Well Name: JRU APACHE FEDERAL COM	Well Location: T22S / R30E / SEC 13 / NESE / 32.391767 / -103.828587	County or Parish/State: EDDY / NM
Well Number: 703H	Type of Well: OIL WELL	Allottee or Tribe Name:
Lease Number: NMNM89051	Unit or CA Name:	Unit or CA Number:
US Well Number:	Operator: XTO PERMIAN OPERATING LLC

Sundry ID: 2839802

Type of Submission: Notice of Intent	Type of Action: APD Change
Date Sundry Submitted: 03/04/2025	Time Sundry Submitted: 08:32
Date proposed operation will begin: 03/07/2025

**Procedure Description:** XTO Permian Operating, LLC. respectfully requests approval to make the following changes to the approved APD. Changes to include SHL, KOP, FTP, LTP, BHL, casing design, cement program, mud circulation system and proposed total depth. FROM: TO: SHL: 2517' FSL & 928' FEL OF SECTION 13-T22S-R30E 2486' FSL & 868' FEL OF SECTION 13-T22S-R30E KOP: 2517' FSL & 928' FEL OF SECTION 13-T22S-R30E 2392' FNL & 330' FEL OF SECTION 13-T22S-R30E FTP: 1650' FNL & 330' FEL OF SECTION 13-T22S-R30E 2392' FNL & 330' FEL OF SECTION 13-T22S-R30E LTP: 1650' FNL & 100' FWL OF SECTION 14-T22S-R30E 2392' FNL & 100' FWL OF SECTION 14-T22S-R30E BHL: 1650' FNL & 50' FWL OF SECTION 14-

[Figure F] 4 String – 2<sup>nd</sup> Intermediate casing engineered weak point

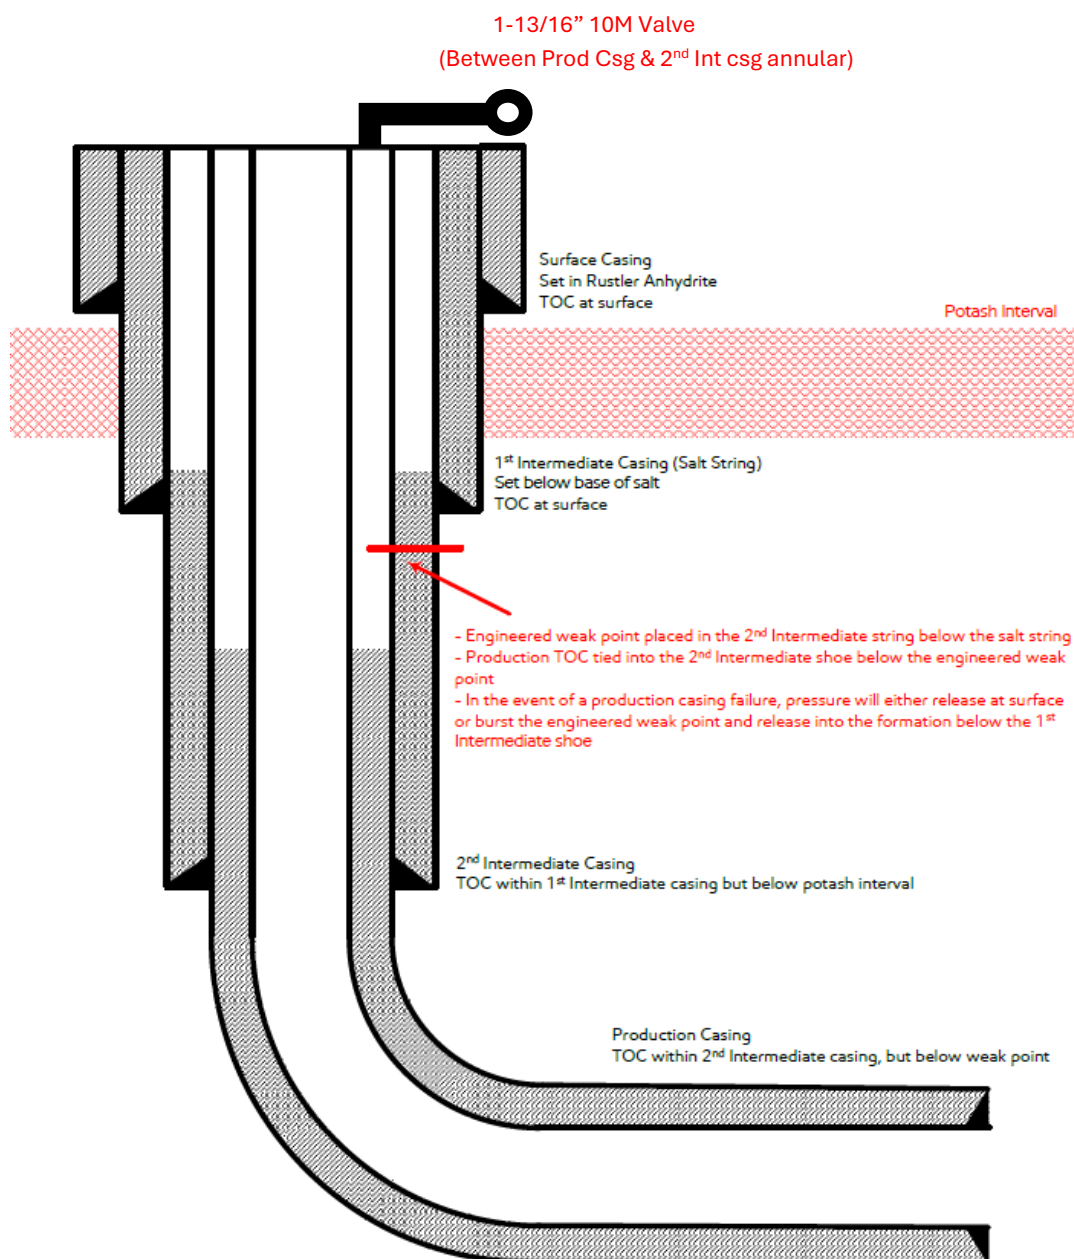
XTO Permian Operating, LLC. respectfully requests permission for a primary and a contingency drilling program for this well. Primary will be a 4-string design with an engineered weak point (R-111-Q: Figure F) & the contingency will be a 3-string design with an open production casing annulus (R-111-Q: Figure B).

- 1) Alignment with KPLA requirements per schematic below, with engineering weak point casing design and utilizing new casing that meets API standards.
- 2) Contingency plans in place to divert fluids away from salt interval in event of production casing failure.
- 3) Intermediate 2 casing will consist of a primary cement job with TOC at the top of the Brushy Canyon formation within the Delaware Mountain Group.
  - a. Bradenhead squeeze to be completed after primary cement job to tie back TOC to intermediate 1 "Salt string" & below Marker Bed 126 "Potash Interval".
- 4) Production cement to be tied back no less than 500' inside previous casing shoe (intermediate 2 casing) and below the engineered weak point.

**Figure B – 3 String Design – Open Production Casing Annulus (Updated May 2024):**

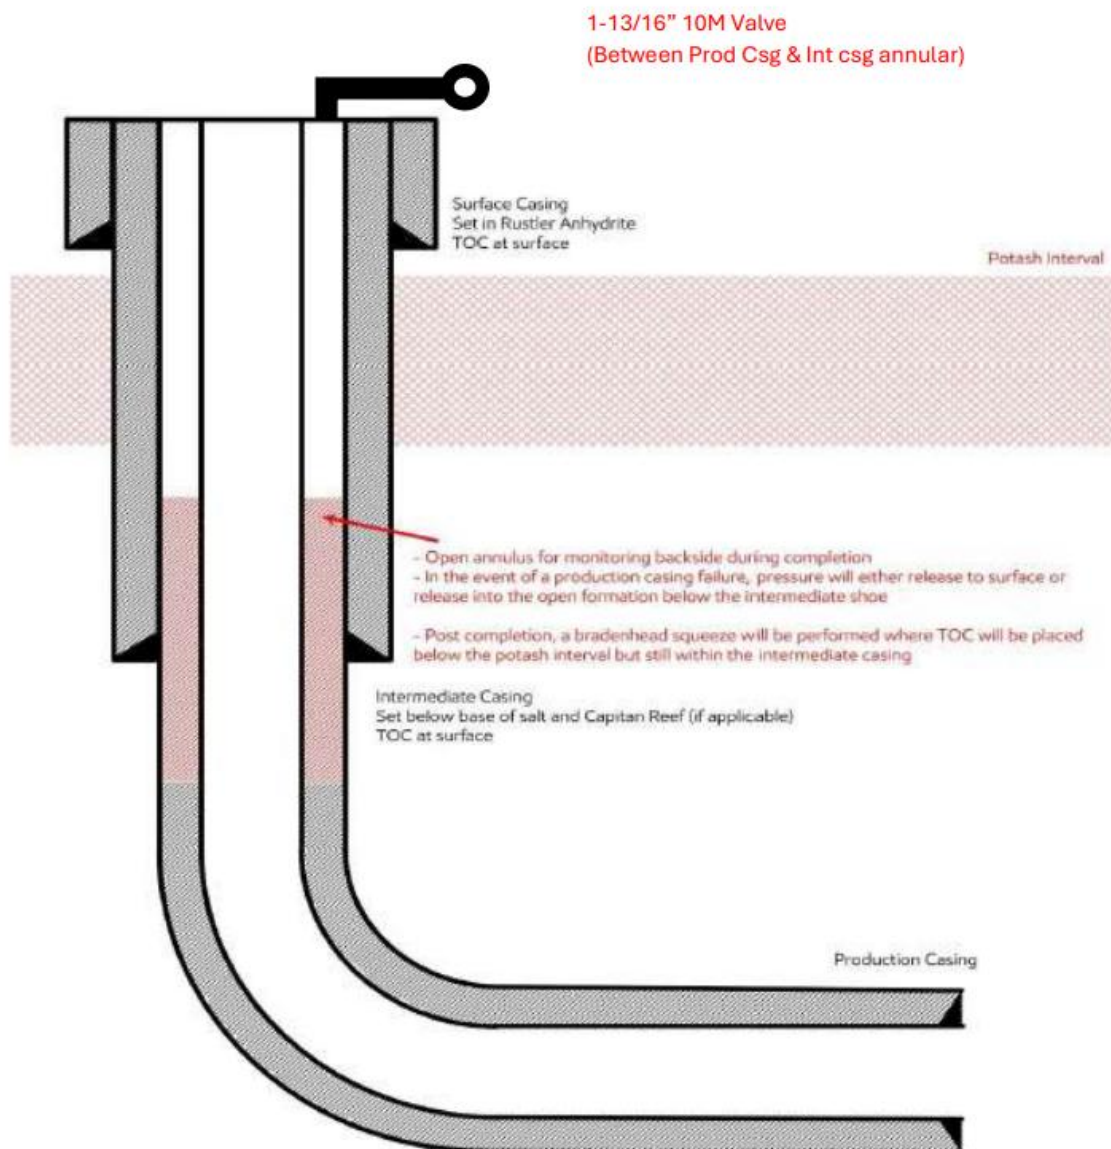
1. Alignment with KPLA requirements per schematic above, leaving open annulus for pressure monitoring during frac and utilizing new casing that meets API standards
2. Contingency plans in place to divert formation fluids away from salt interval in event of production casing failure
3. TOC in the annulus between intermediate & production casing string shall stand uncemented at least 500 feet below the intermediate casing shoe
4. Bradenhead squeeze to be completed within 180 days after hydraulic frac operations have been concluded to ensure at least a 500 feet tie-back has been established inside salt string but with top below MB 126
